ADDENDUM NUMBER: Three (3)

TITLE: IFB FY26 Light Duty Vehicles, Medium Duty Vehicles, and Vans – 1412056646

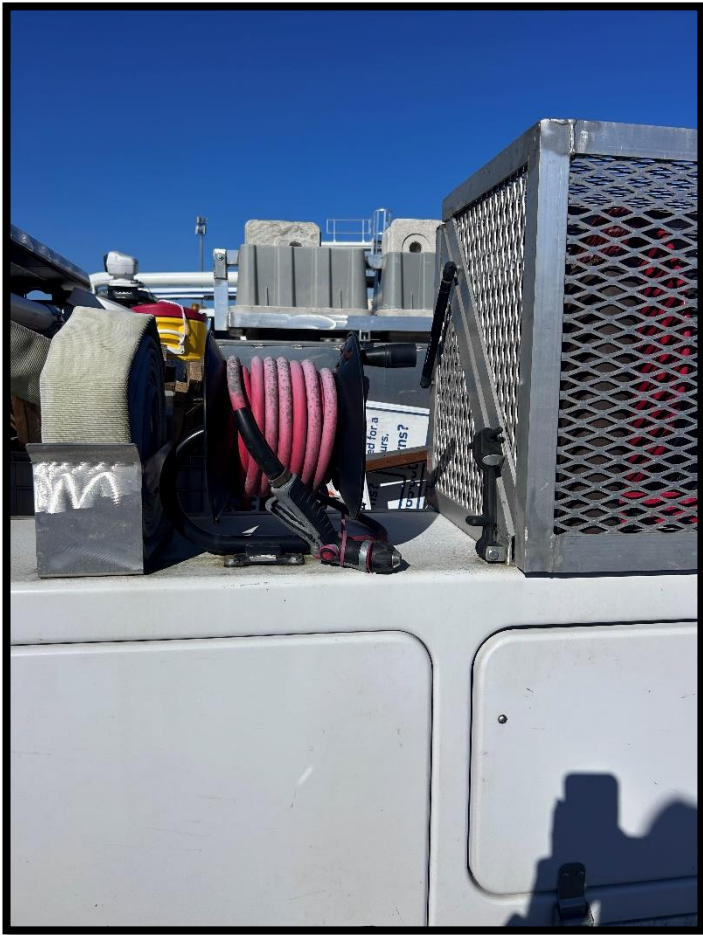
5. **Question:** Reference - 122+ EXT CAB SRW (Option A): Can you please provide more photos and specifications for the following: 50 Gallon Water Tank, 4.5 GPM Pump Package (must be rated for continuous outdoor use in all weather conditions) with electric start (JM-2900 GAS JET or Equal), 4.5 GPM Electric Lift Pump, Retractable Reel, Fill Hose, Expanded Aluminum Pump Guard and all Brackets and Hardware.

Answer: Please find requested photos pasted below.

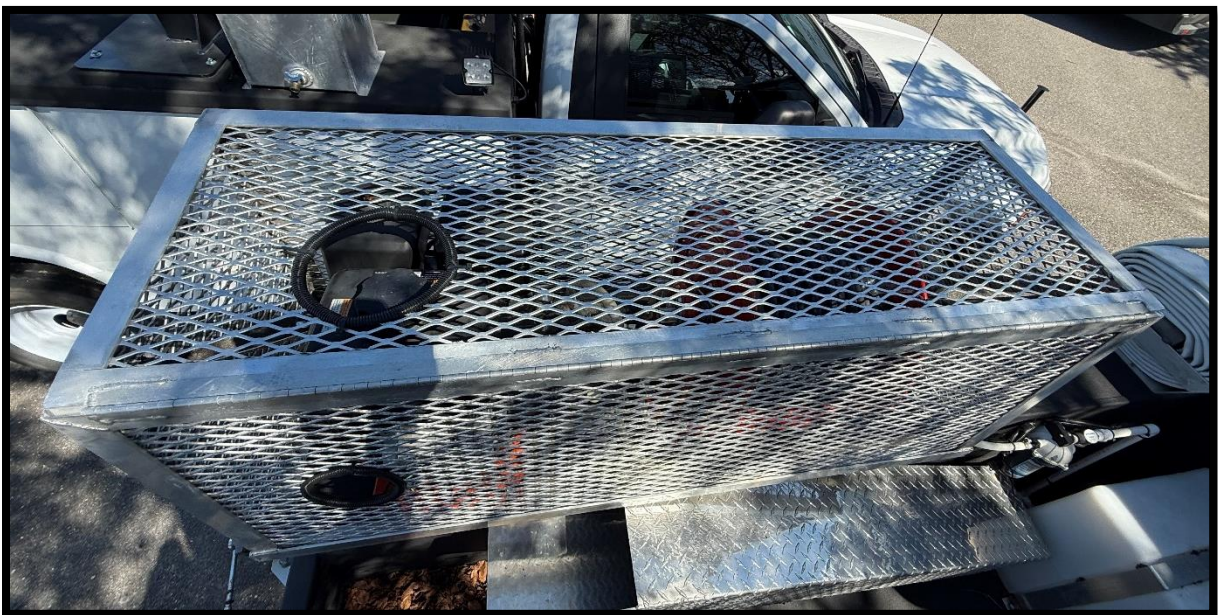
4. **Question:** Reference - 122 (Option C): Will you accept a steel or aluminum body in lieu of composite?

Answer: These will need to be steel bodies. Please list any exceptions with your bid.

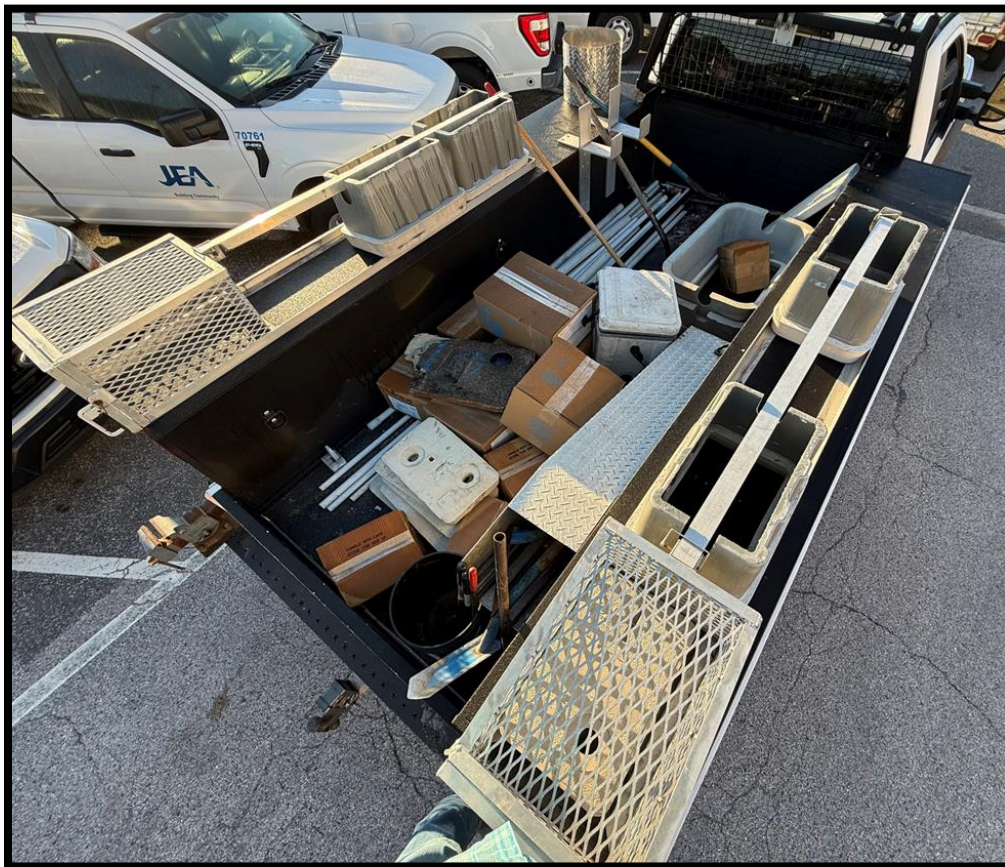
7. **Question:** Reference - 122+ EXT CAB SRW (Option A): Can you please provide more photos and specifications for the following: 72" Long meter rack mounted on top of bin curb side.

Answer: Approximately 72" Long, 14" wide and 1' tall (10 3/8" to the bottom of the meter hold down bar). No expanded metal box at the end of the meter rack (see red X in the image below).

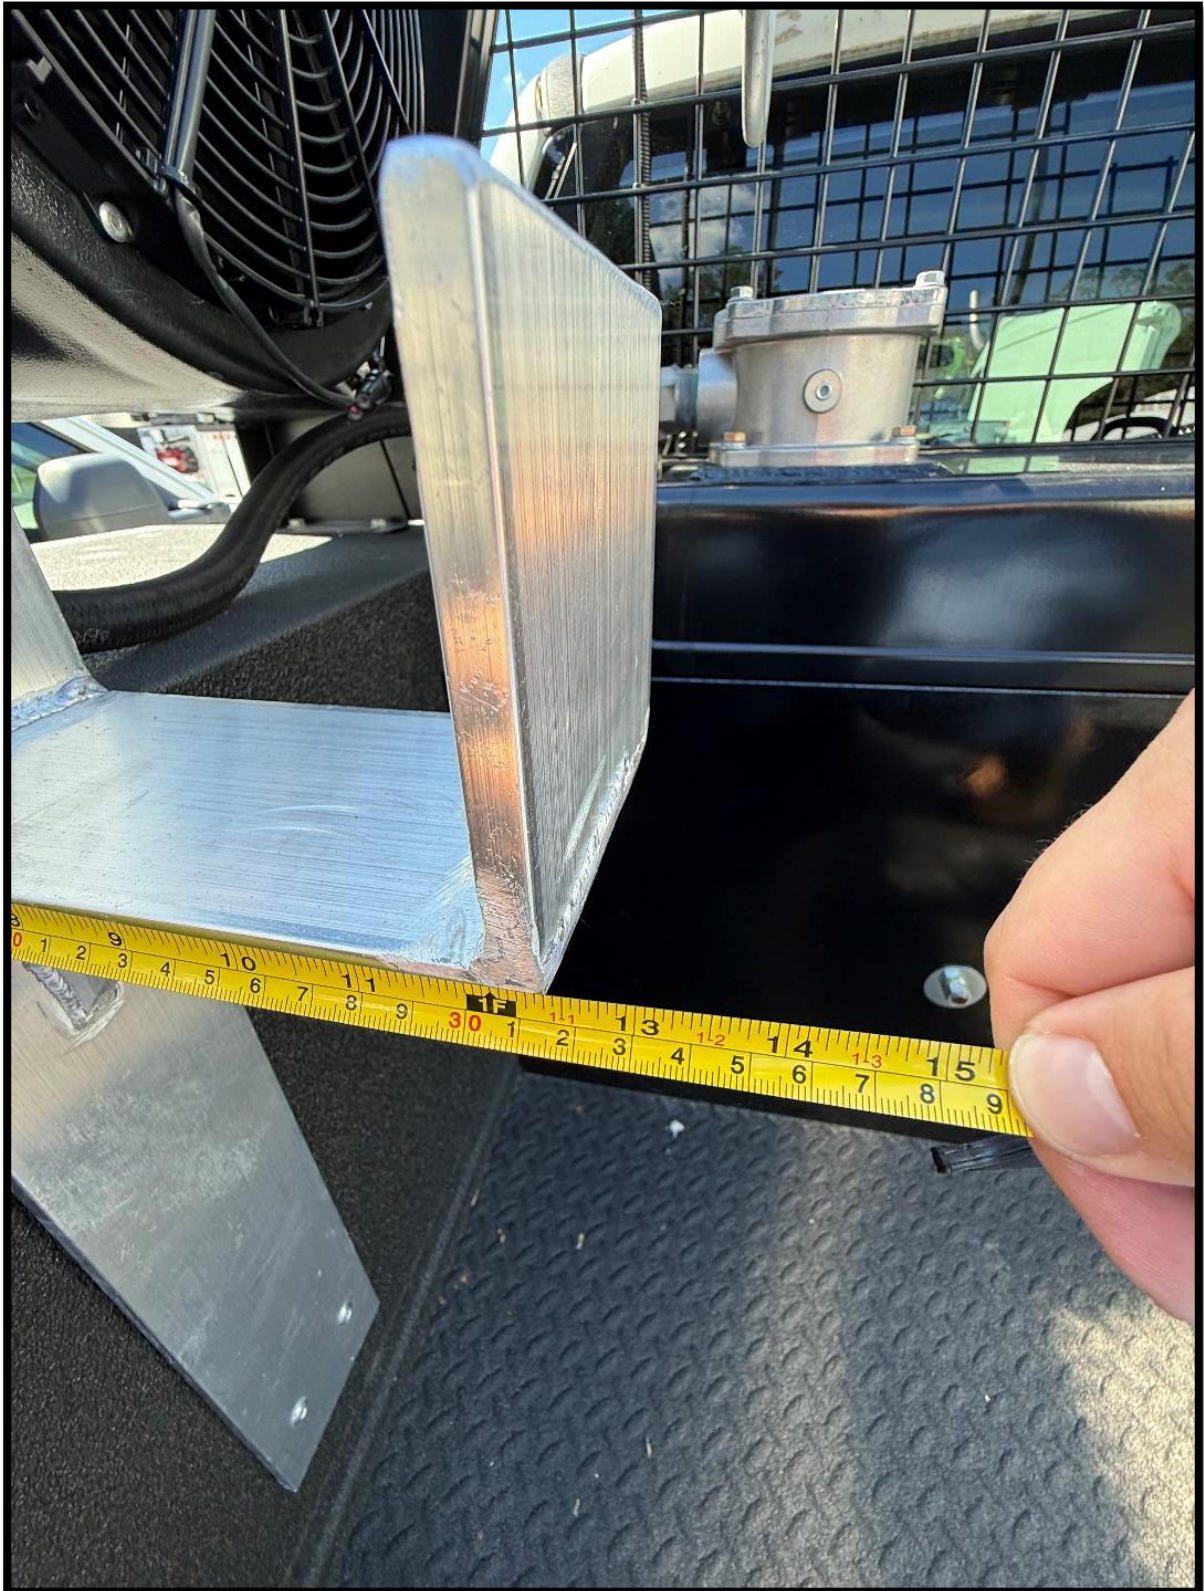
10. **Question:** Reference - 123 STANDARD CAB 2WD (Option E): Can you please provide photos & additional specifications for: RESIDENTIAL Meter Box Racks (2): DS & PS top of utility body.

11. Question: Reference - 123 STANDARD CAB 2WD (Option E): Can you please provide photos & additional specifications for: Aluminum Shovel Rack (10" Wide Version); Mount RR inside utility bed.

Answer: Please find requested photos pasted below.

Answer: Same dimensions as the "Key Rack" in option "J" listed below in Answer #12.

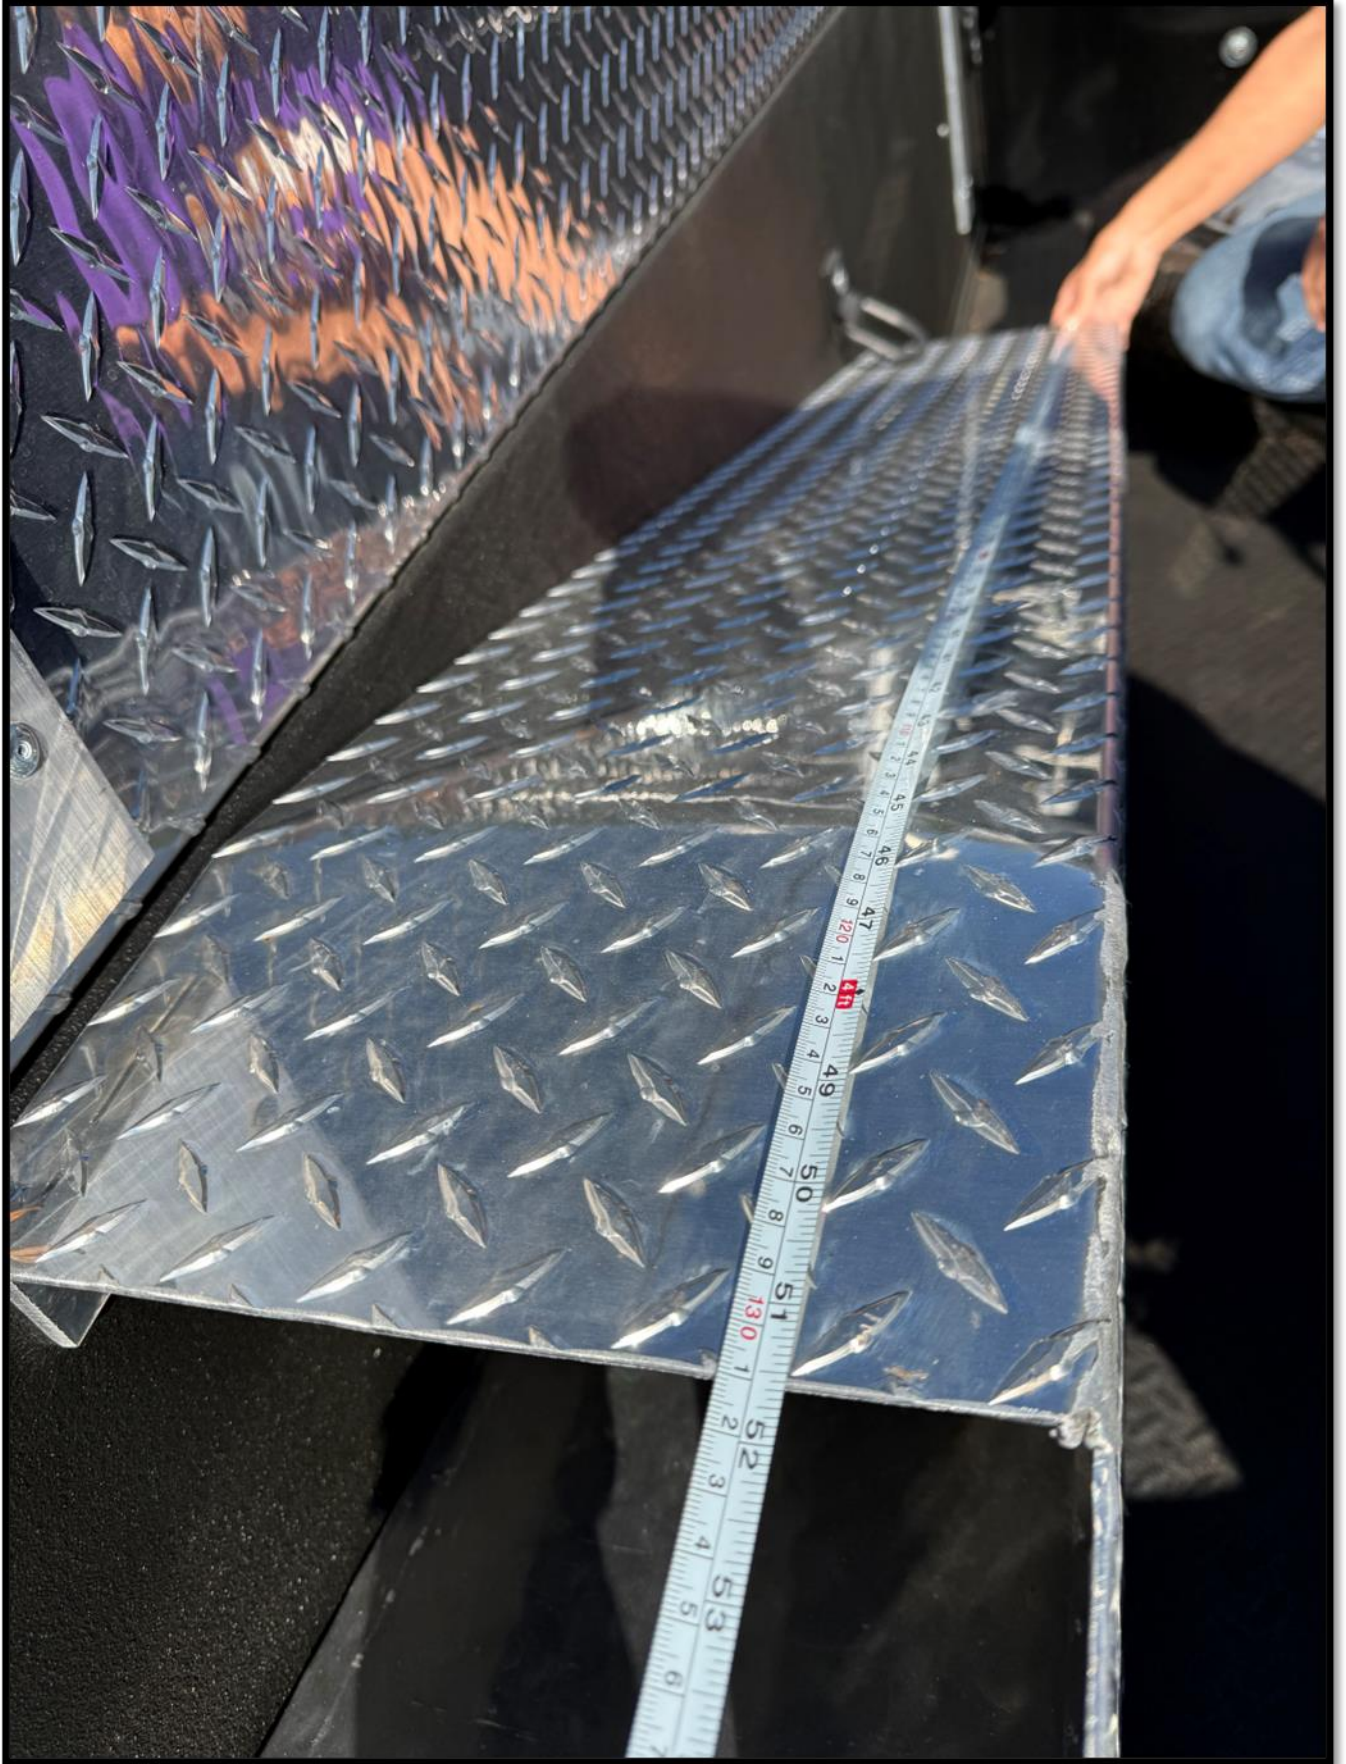
13. Question: Reference - 123 STANDARD CAB 2WD: Option J: Please provide photos and additional specifications for “Aluminum Key Rack: Mounted inside RR utility body “Upgraded Design.”

Answer: Please find requested photos pasted below.

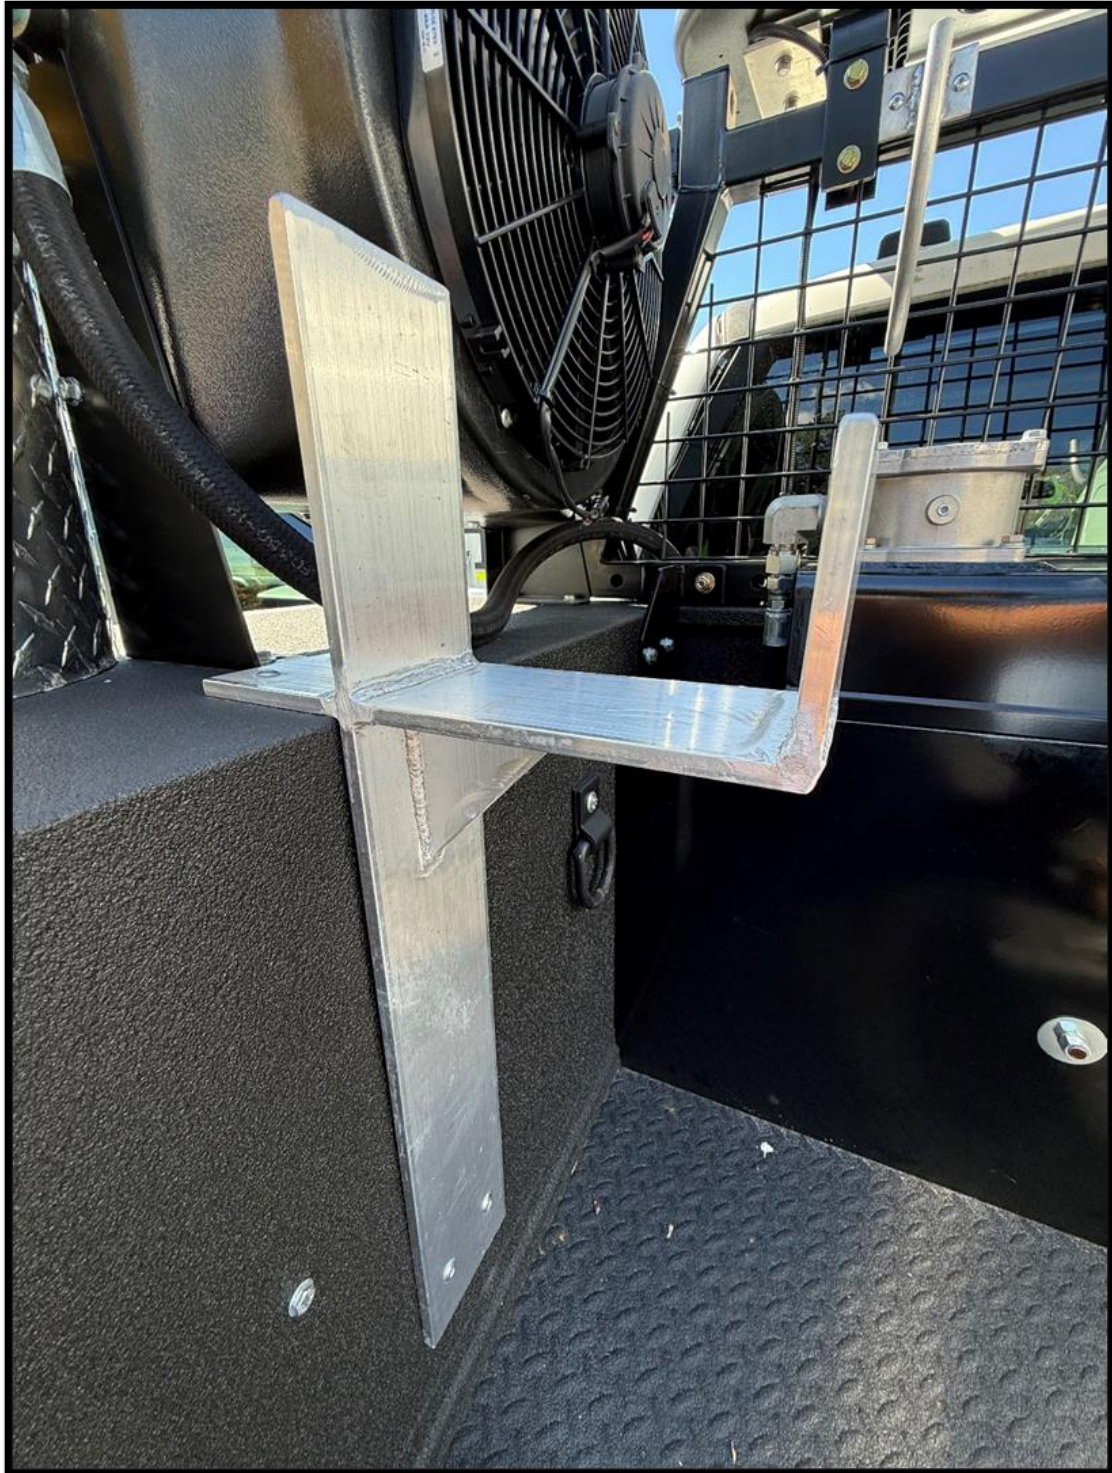
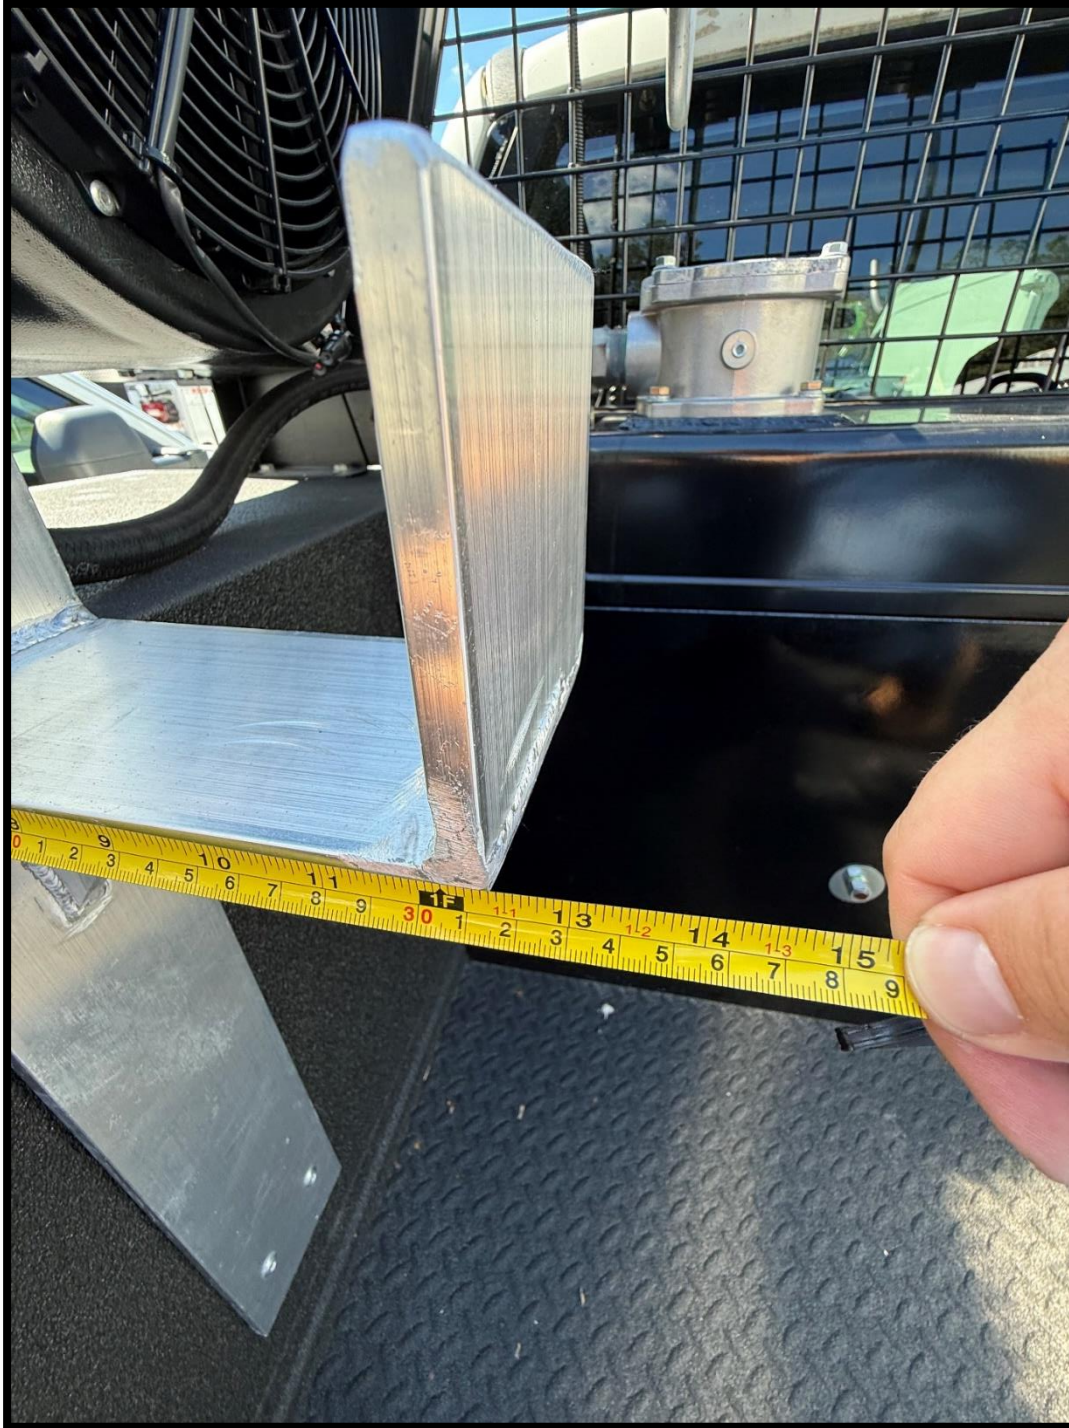
14. Question: Reference - 123 EXT CAB 4WD (Option N): Please provide photos & additional specifications for: "Aluminum Poly Rack: Mounted StreetSide."

Answer: Please find requested photos pasted below.
